**The Ohio State University
Nuclear Reactor Laboratory**

**RE: REQUEST FOR ADDITIONAL INFORMATION REGARDING THE OHIO STATE
UNIVERSITY RESEARCH REACTOR APPLICATION FOR RE-LICENSING
(TAC NO. MA7724)**

REQUESTED ADDITIONAL INFORMATION REGARDING THE OHIO STATE UNIVERSITY RESEARCH REACTOR (OSURR) - DOCKET NO. 50-150

Figure 6.1: Administrative Organization

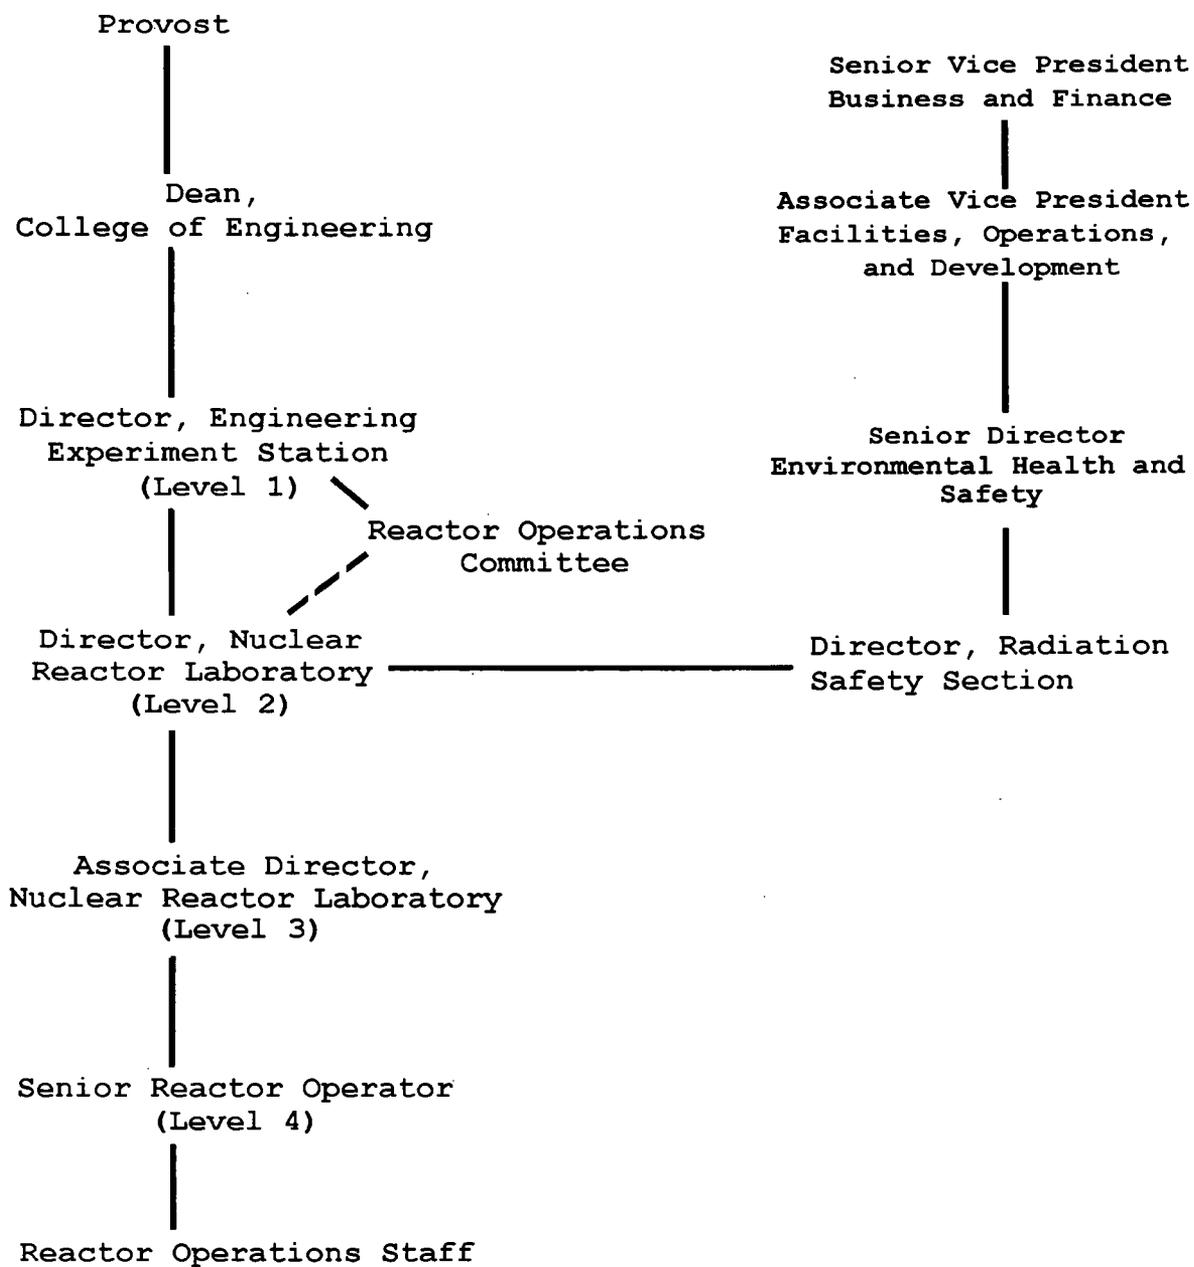
97. § 6.1 – Updated Figure 6.1 to reflect current administrative organization structure for the OSURR.
- Make TSs consistent with Amendment #18 to the Facility Operating License for the OSURR.

98. § 6.1 – Updated Figure 6.1 to reflect changes in Section 6.2 (ROC to report to Level 1 Management now)
- Align with ANSI/ANS-15.1-1990 recommendations

99. § 6.1 – Updated Figure 6.1 to reflect changes in position titles for those above the Director of the Radiation Safety Section. Paths of responsibility have not been changed, so therefore independence from OSURR management is not affected; only position titles have changed.
